STAFF REPORT
COMMUNITY DEVELOPMENT DEPARTMENT

HEARING DATE: 2/22/2022
 TO: Mayor & City Council
 FROM: Joe Dodson, Associate Planner
 208-884-5533
 SUBJECT: H-2021-0071
 Lennon Pointe Community
 LOCATION: The site is located at 1515 W. Ustick Road, in the southeast corner of N. Linder Road and W. Ustick Road, in the NW ¼ of the NW ¼ of Section 1, Township 3N., Range 1W.

I. PROJECT DESCRIPTION

LANDSCAPE PLAN AREA ONE

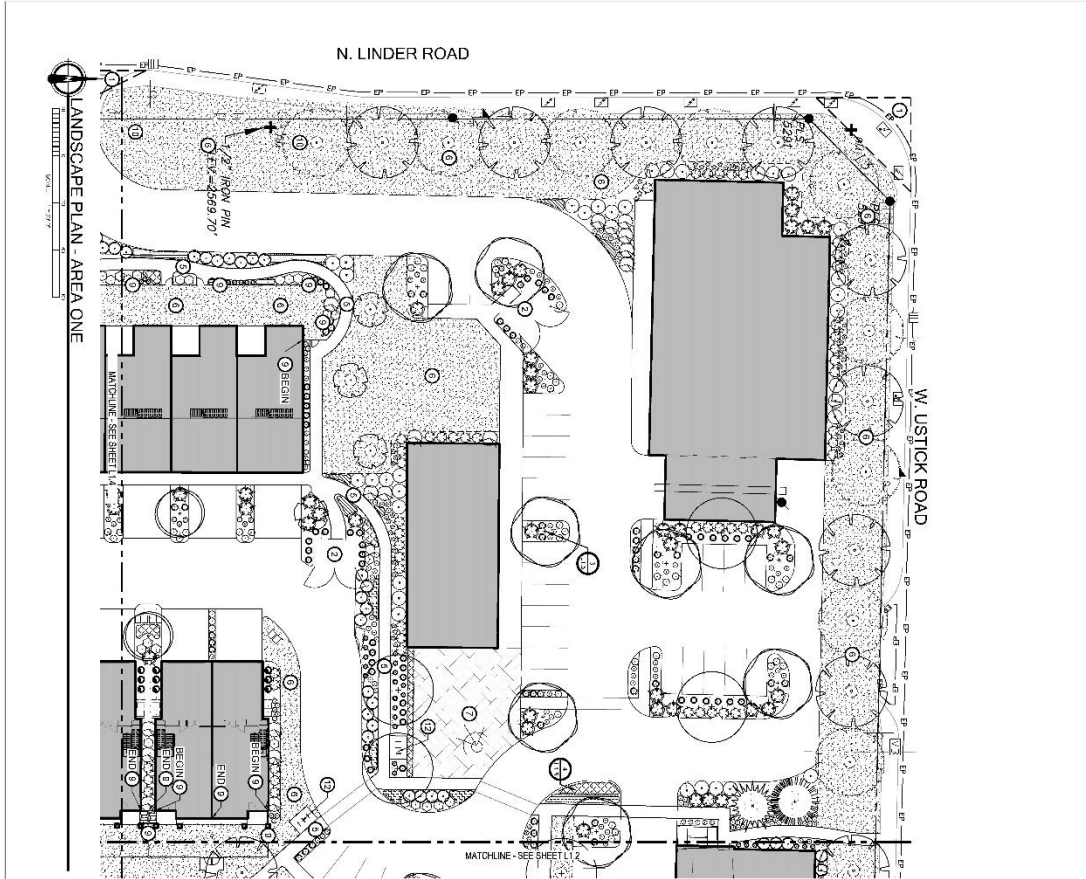
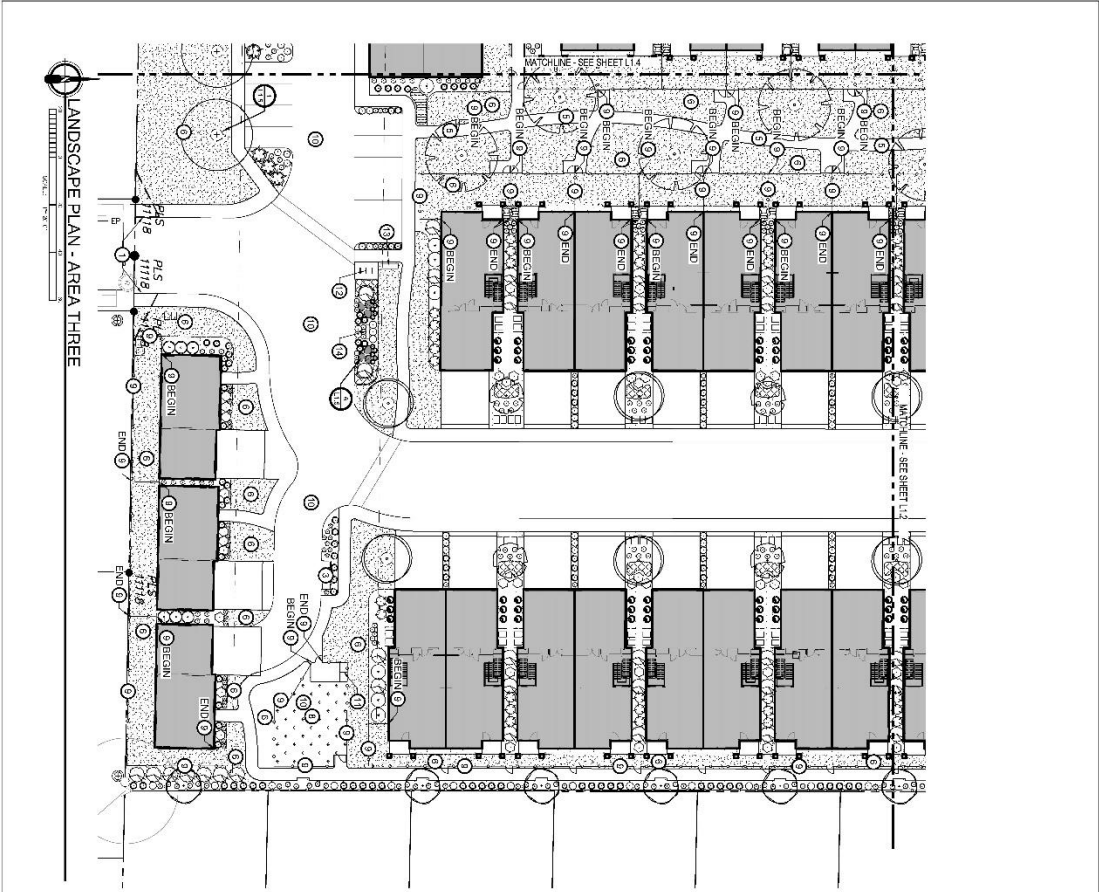
*In addition, an area of the Creason Lateral and Kellogg Drain irrigation easements underlay a large portion of the landscape buffer along Linder Road that is currently shown with trees. Staff anticipates the applicable irrigation district will not allow trees within their easements so the landscape plans should be revised to show the removal of trees from the easement area. Furthermore, code requires that if a required landscape buffer is encumbered by easements, at least 5 feet of landscaping be proposed outside of the easement area to include the required number of trees. **Because of the extensive impediment these two irrigation facilities create in this area of the site, Staff does not find it feasible to comply with this code requirement in its fullest extent as it would require half of the site to shift to the east reducing the width of the new in the center of the development. Staff finds the trees that are allowed outside of the easement area, the placement of the access point to Linder, and the separation of the townhome units from Linder offer appropriate and adequate landscaping and buffering. However, to formalize this finding and comply with code, the Applicant should apply for Alternative Compliance with the first final plat application.***

According to the submitted landscape plans, the proposed regional pathway in the southwest corner of the site is also within the Kellogg Drain irrigation easement which generally does not allow trees and minimal landscaping. The submitted landscape plans show no trees proposed within this easement.

According to the submitted plans, a 20-foot buffer is proposed to be shared over the commercial property boundary – 10 feet on the commercial property and 10 feet on the residential side. It appears the additional required 5 feet of area can be easily accommodated and will not require any revision to the placement of buildings. In addition, in order to allow the commercial site to be more viable and the fact the proposed development is planned together, Staff approves of the proposal to share the width of the 25-foot landscape buffer across the shared property line.

- a. Revise the location of the trees for the Linder Road street buffer to be outside of any waterway easement.
 - b. Shift the proposed regional pathway on Lot 1, Block 1 to the west to better align with the approved segment to the south in Creason Creek No. 2.

- c. Show the required 25-foot landscape buffer between the C-C zoning district and the R-15 zoning district as required by UDC 11-3B-9C.
 - d. Revise the landscape plan to match the revised preliminary plat and site plan dated January 2022.

E. Site Plan (Revised January 2022)

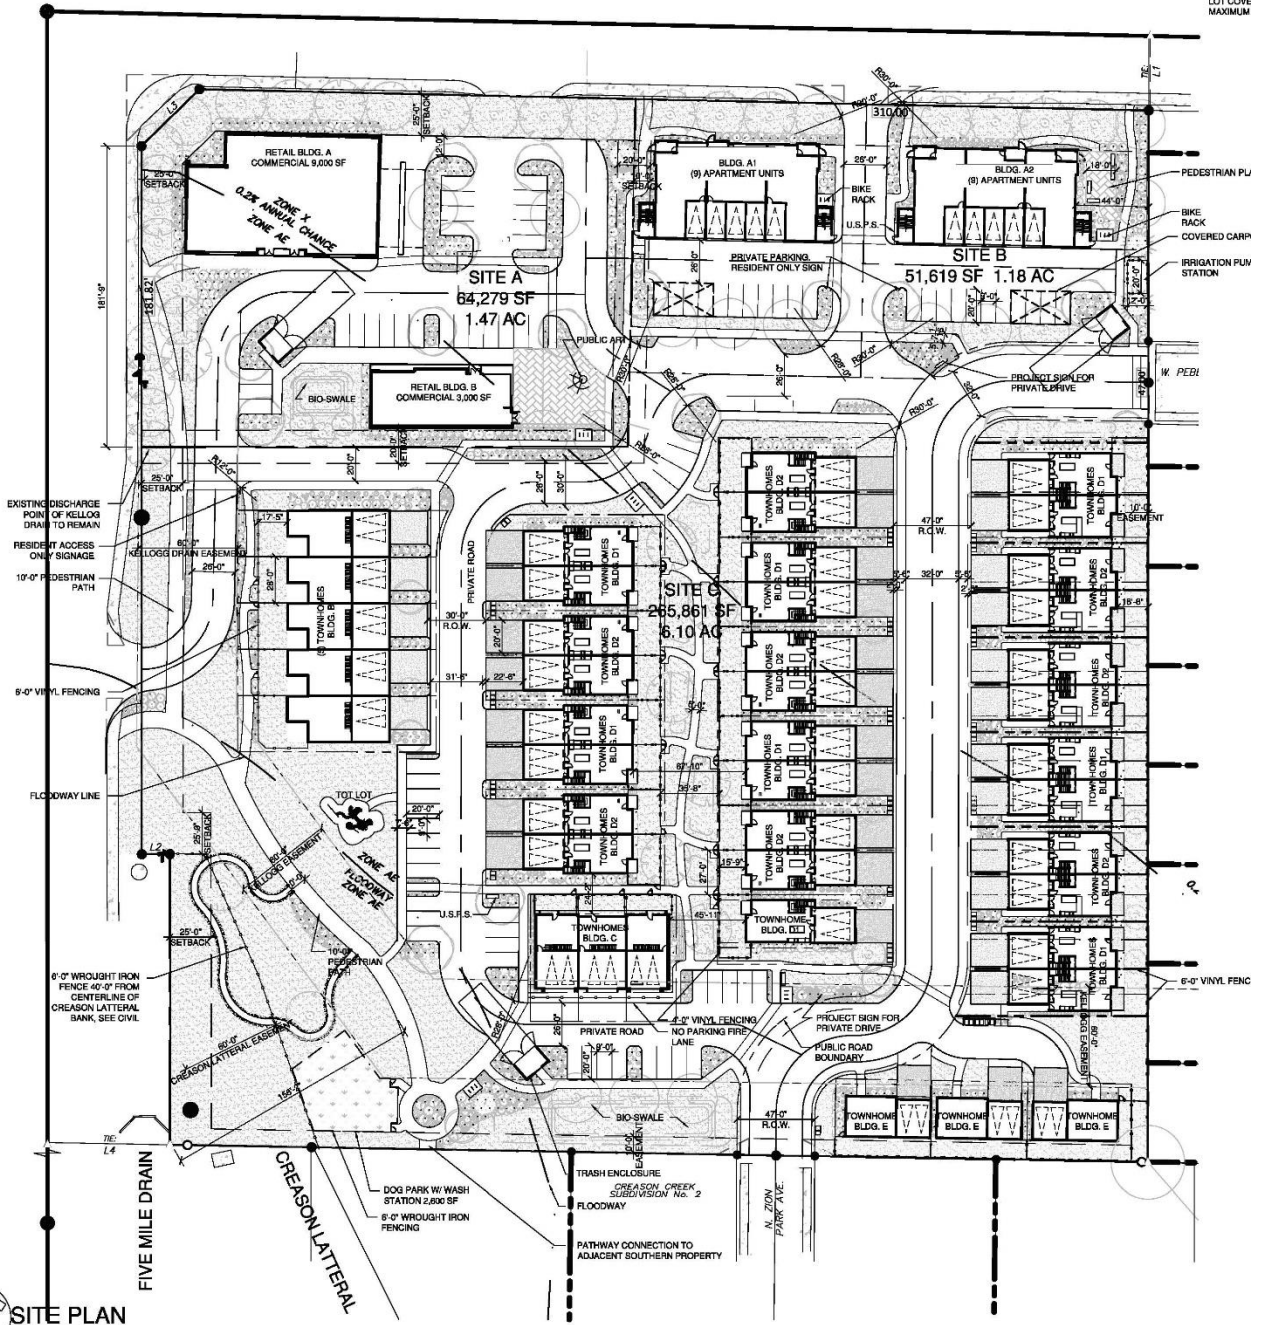
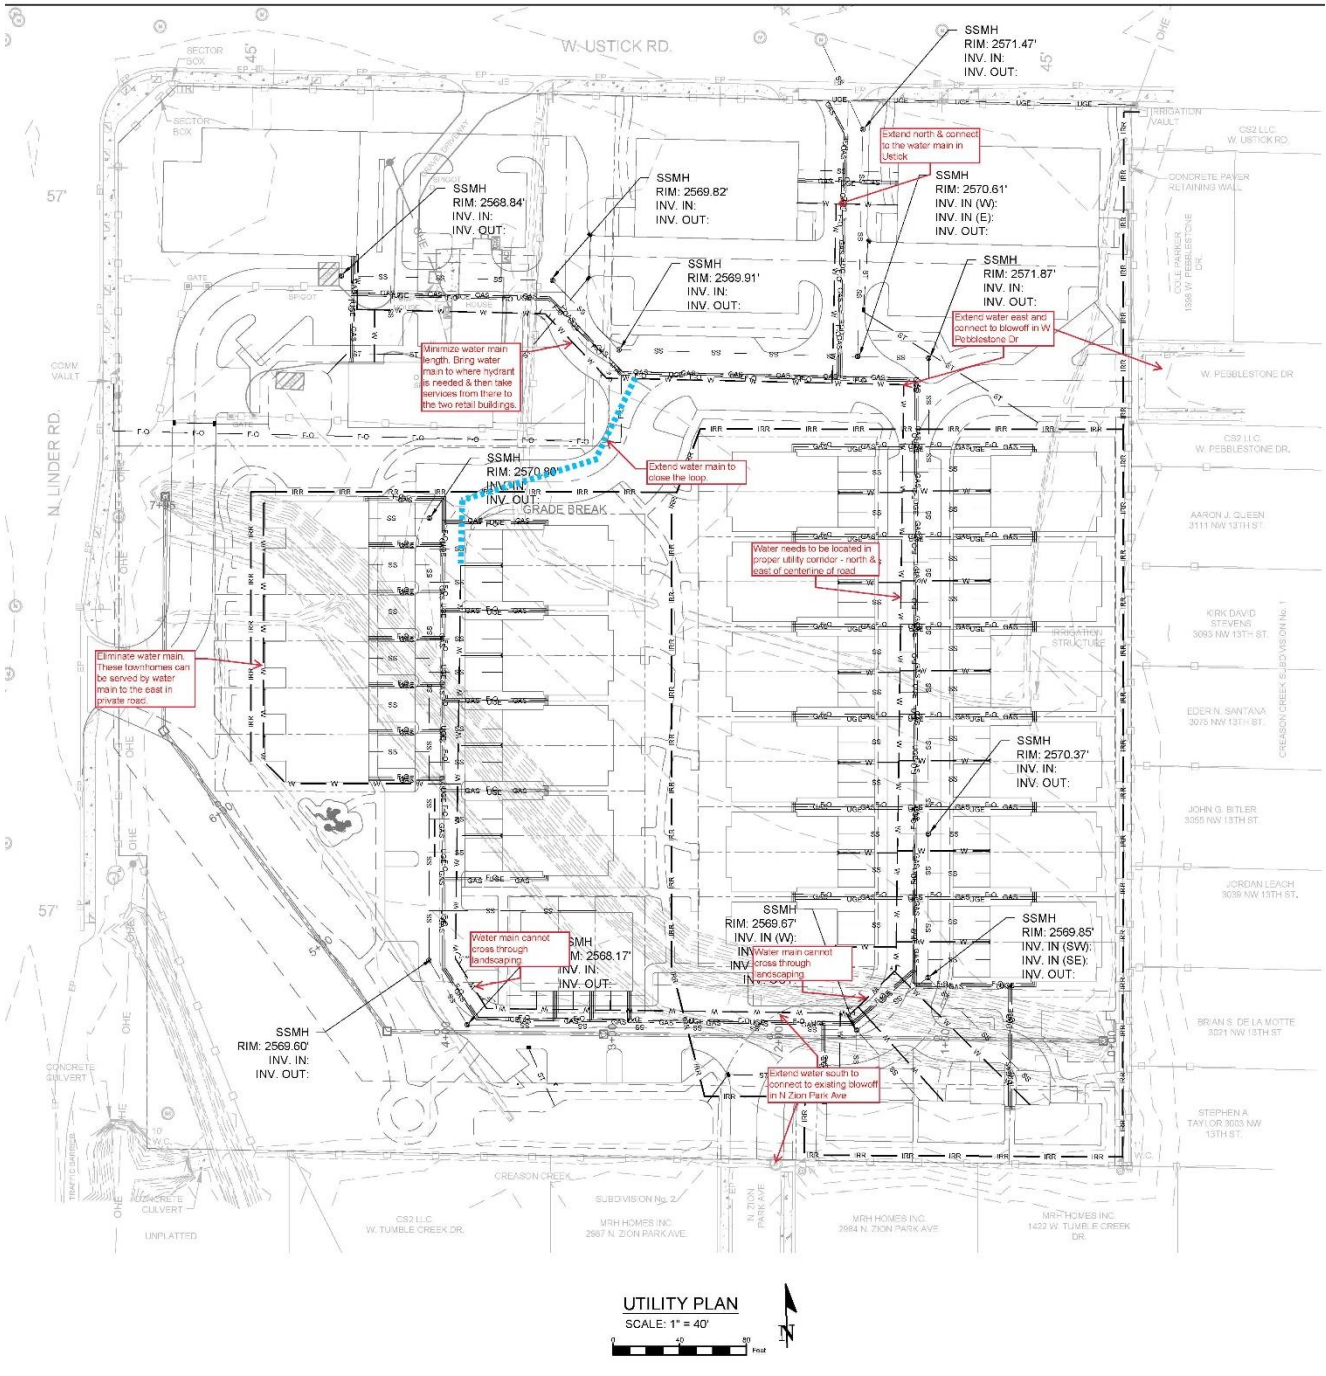
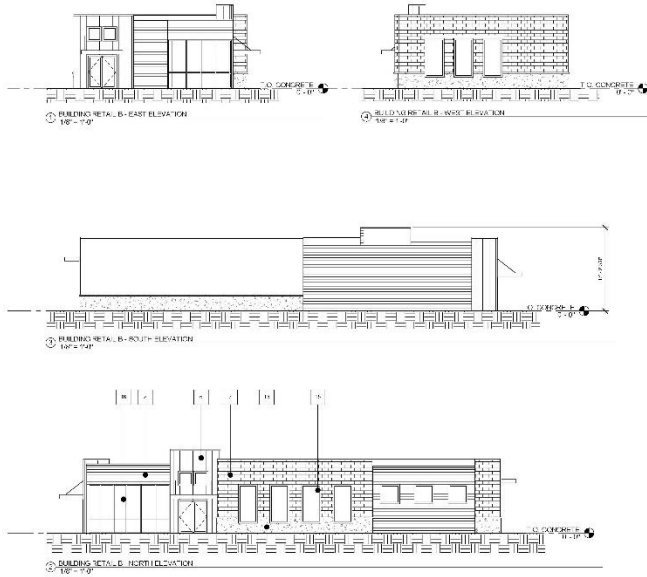
Furthermore, it appears the site plan shows building footprints too large for the proposed building lots—the building footprints do not meet the minimum building setback to the entrance sidewalks of 10 feet. When future building permits are submitted, the Applicant will be required to show compliance with all R-15 dimensional standards as outlined in [UDC Table 11-2A-7](#).

The commercial area proposed in the northwest corner of the site is shown with two buildings totaling approximately 12,000 square feet requiring at least 24 parking spaces based on the nonresidential parking ratio of 1 space for every 500 square feet of commercial gross floor area. *According to the submitted site plan, 25 parking spaces are being proposed. Each space appears to meet the minimum dimensional standards of 9' x 19' as well. Complete analysis of the proposed commercial area will take place with the first CZC application for the commercial site. Initial analysis shows compliance with all UDC dimensional standards except for how the drive aisle along the north and east of the commercial site functions. The drive aisle along the north boundary of the site is shown as 12 feet wide which implies a one-way drive aisle and it leads to the drive aisle along the east boundary of the site that is shown as approximately 26 feet wide which implies two-way traffic. There does not appear to be a need for the eastern drive aisle to allow two-way traffic if the north drive aisle is a one-way exit in this area.*

A portion of one of the building lots (Lot 2, Block 1) is shown on the preliminary plat and site plan within the floodplain area. The building footprint is not so this technically complies with City and floodplain standards. However, to ensure the future homeowner has the easiest access to use their property, Staff recommends this 6-unit townhome building be shifted to the north to get as much of the building lot out of the floodplain as possible. There is adequate room on the north side of this building for this to occur without any other changes to the development.

4. The site plan, as shown in Exhibit VII.E, shall be revised as follows prior to Final Plat submittal:
 - a. ~~Shift the 6 unit townhome building to the north to move as much of Lot 2, Block 1 out of the floodway zone.~~

- c. Show the required number of covered spaces for the proposed multi-family residential development, per UDC Table 11-3C-6.
 - d. Shift the proposed regional pathway on Lot 1, Block 1 to the west to better align with the approved segment to the south in Creason Creek No. 2.
